**SUBMITTAL TO THE BOARD OF SUPERVISORS  
COUNTY OF RIVERSIDE, STATE OF CALIFORNIA**

**SUBJECT:** DEPARTMENT OF WASTE RESOURCES: Contract Change Order No.1 for the Construction of Daily Cover Excavation and On-Call Site Improvements at Badlands and Lamb Canyon Sanitary Landfills, District 5 [\$921,740 –Department of Waste Resources Enterprise Funds] (Nothing Further Required under CEQA)

**CONTRACT CHANGE ORDER NO. 1**

Wastewater Percolation Basin

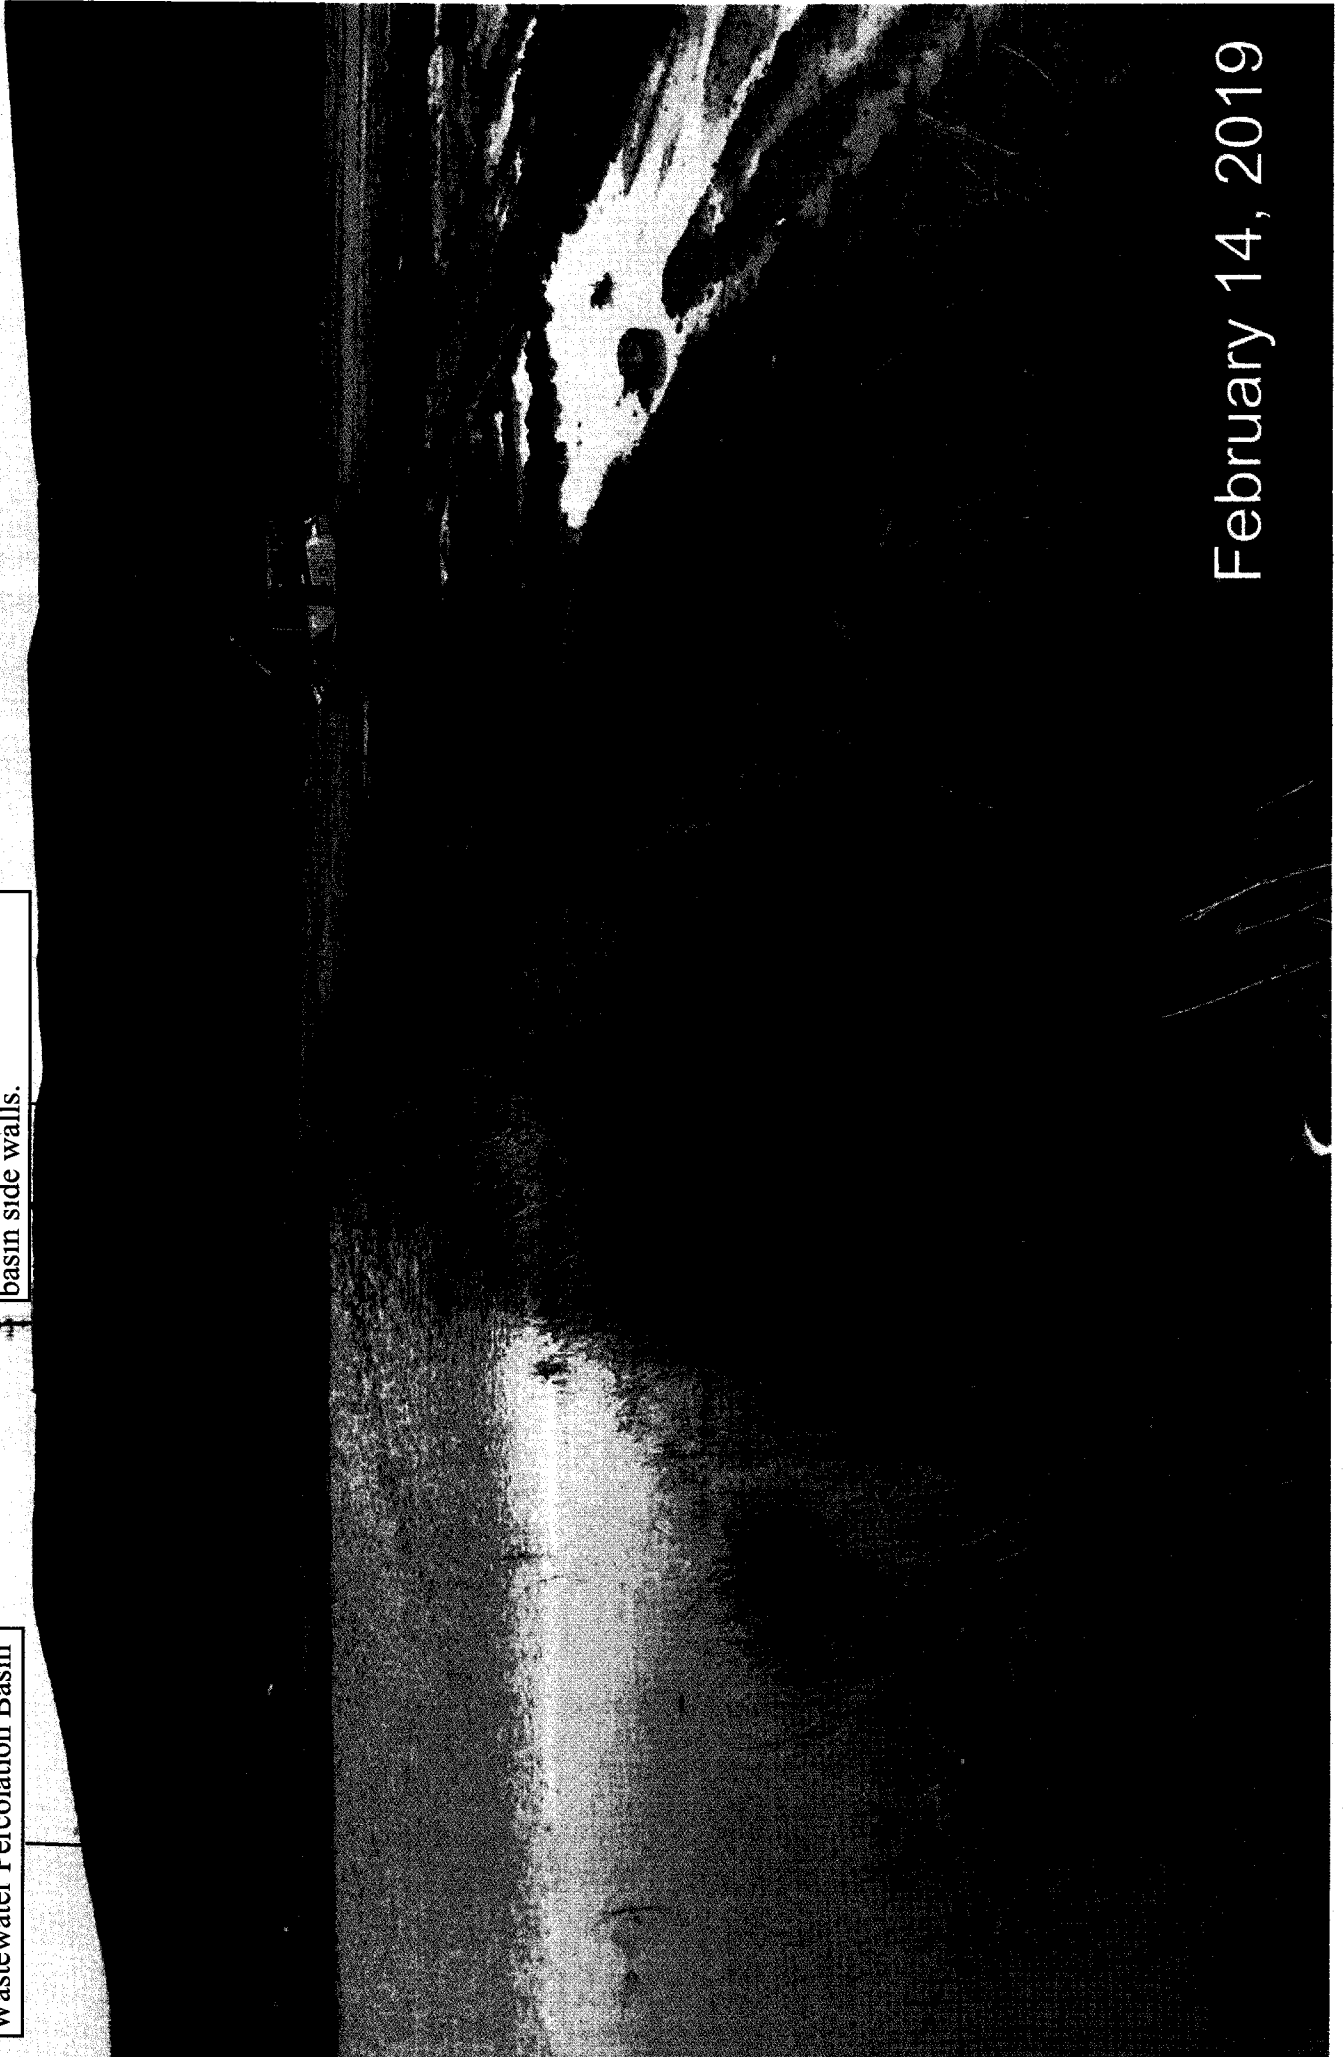
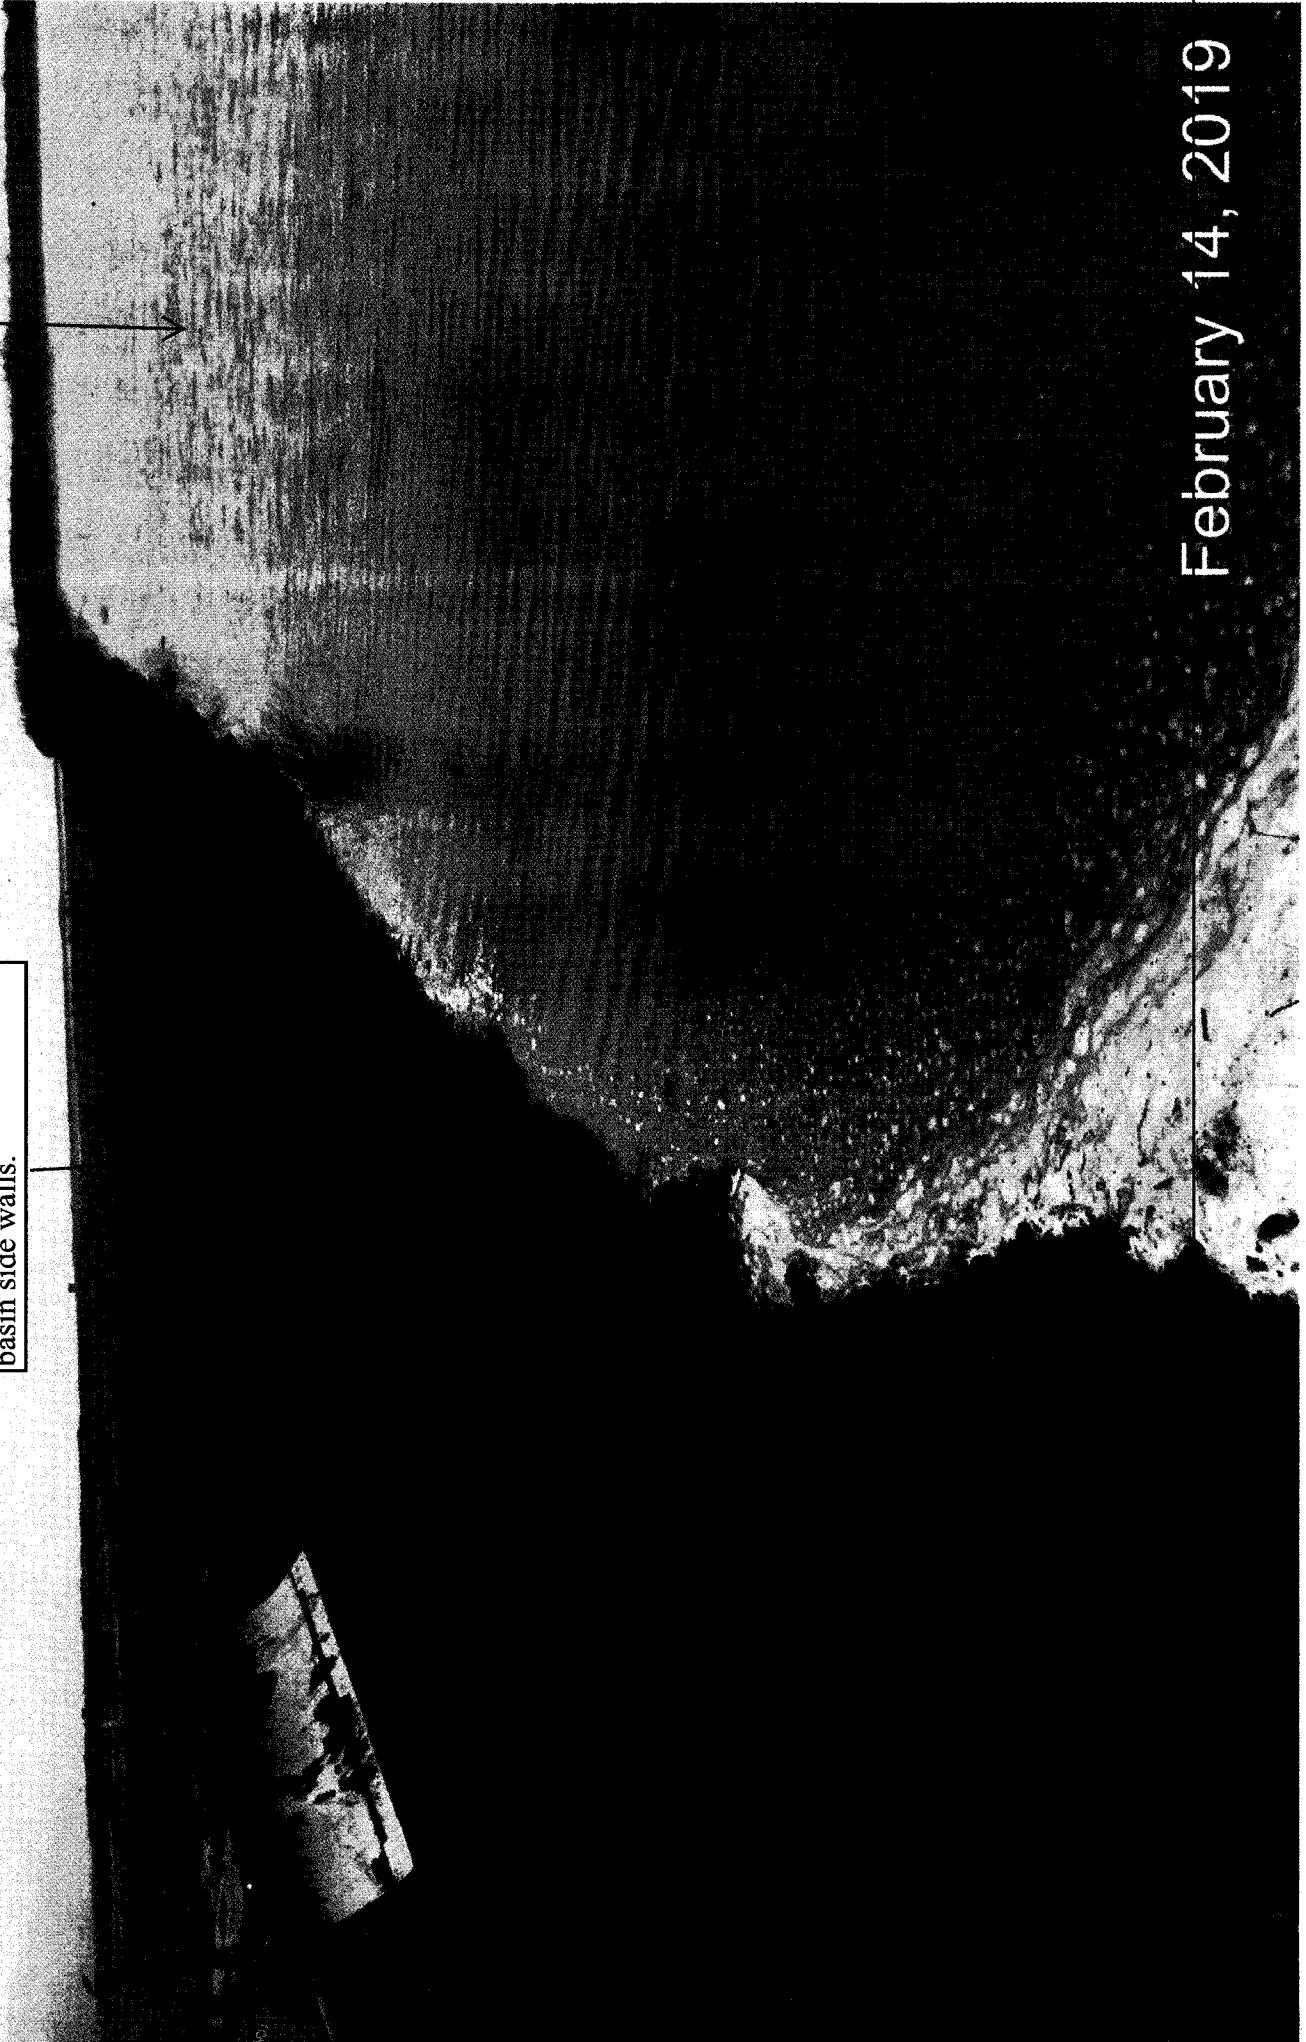
Contractor increased height of basin side walls.

Repair Work Item No.1 & No.6

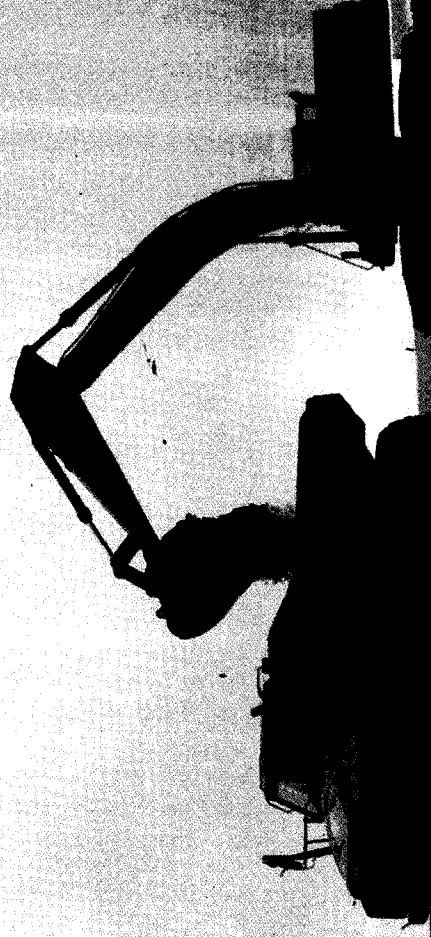
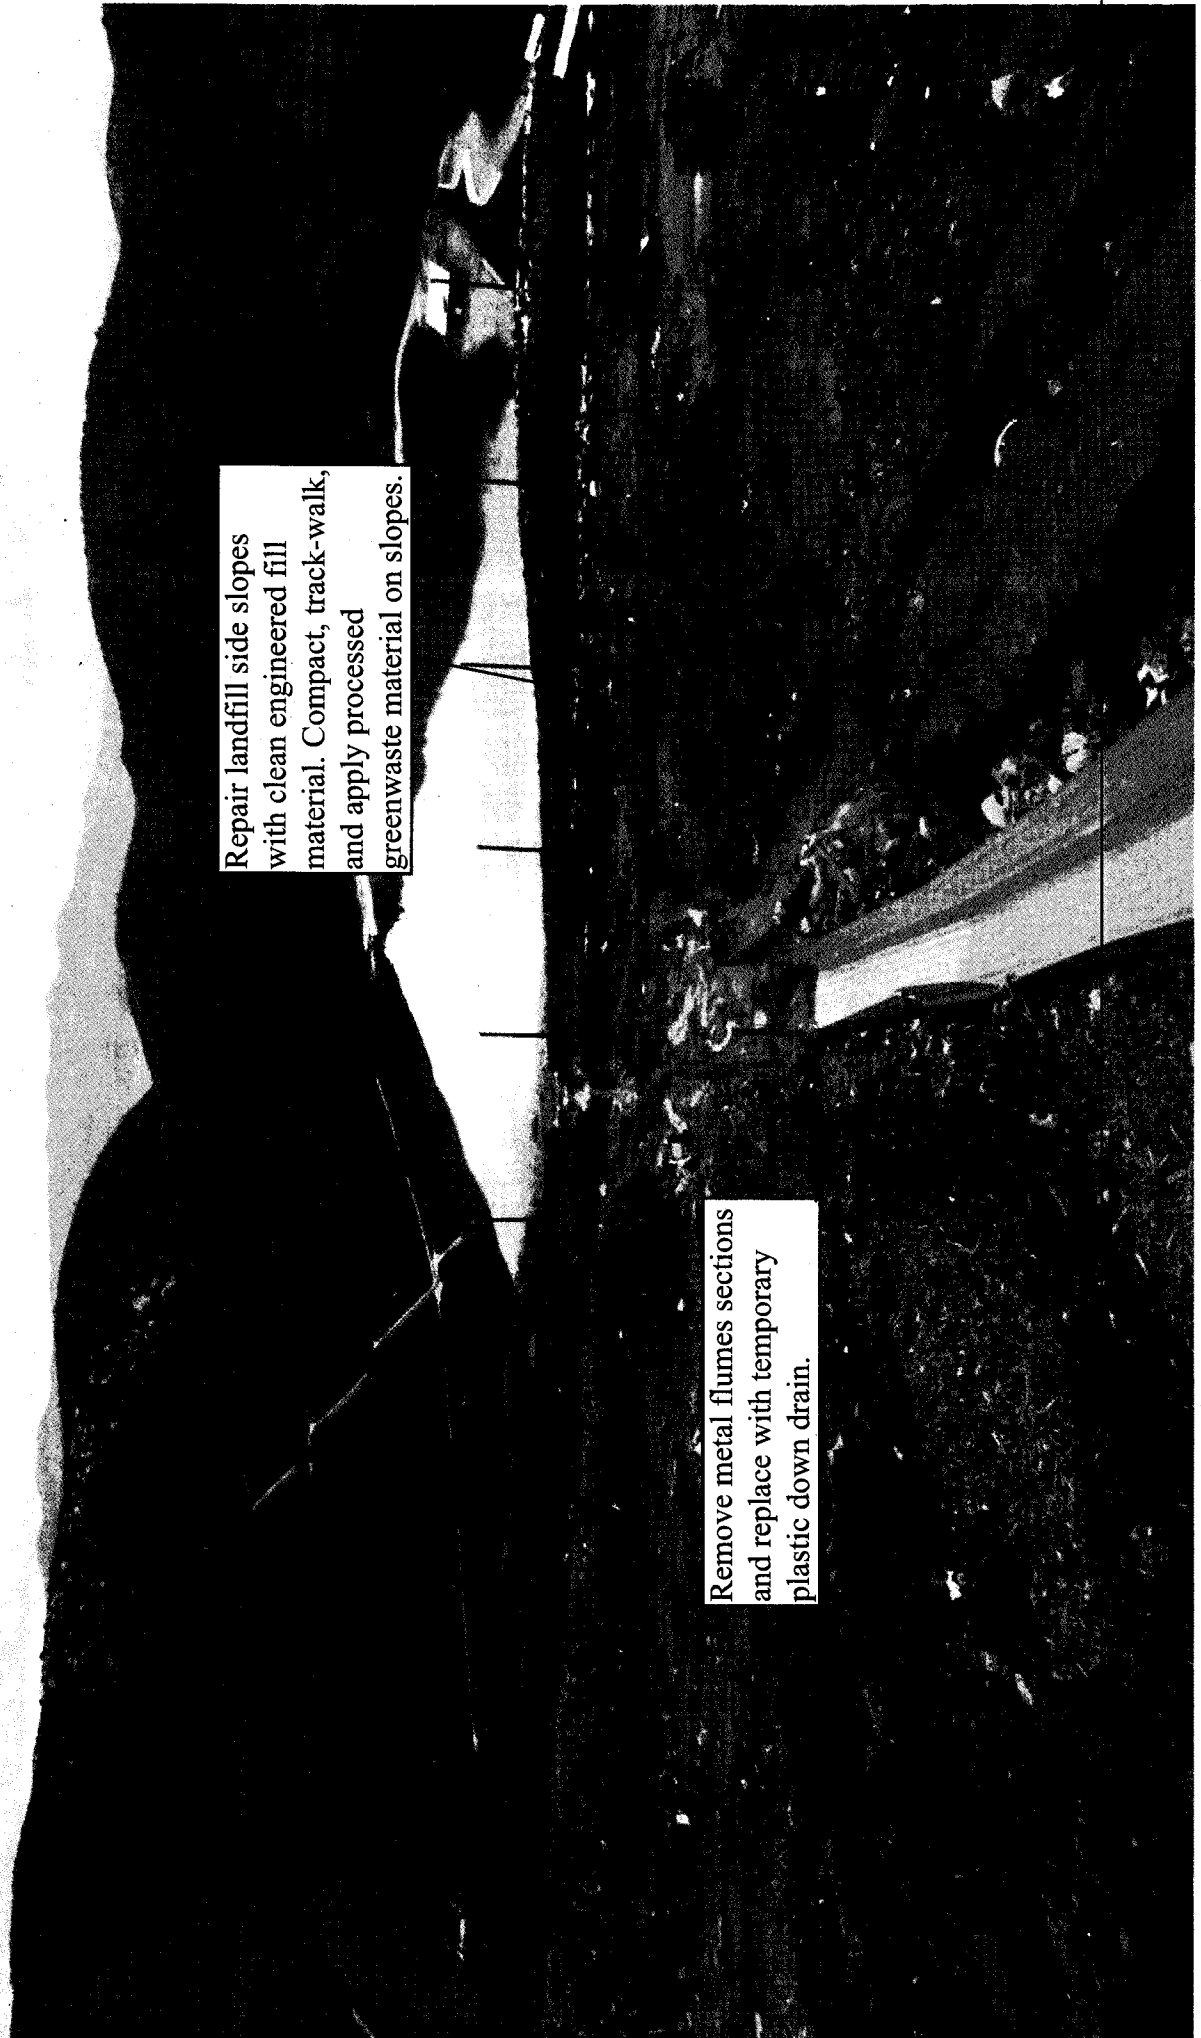
Material utilized to increase the height of the basin walls was obtained from the existing Landfill Access Road. Access road to be reconstructed by Contractor after emergency repair work is completed.
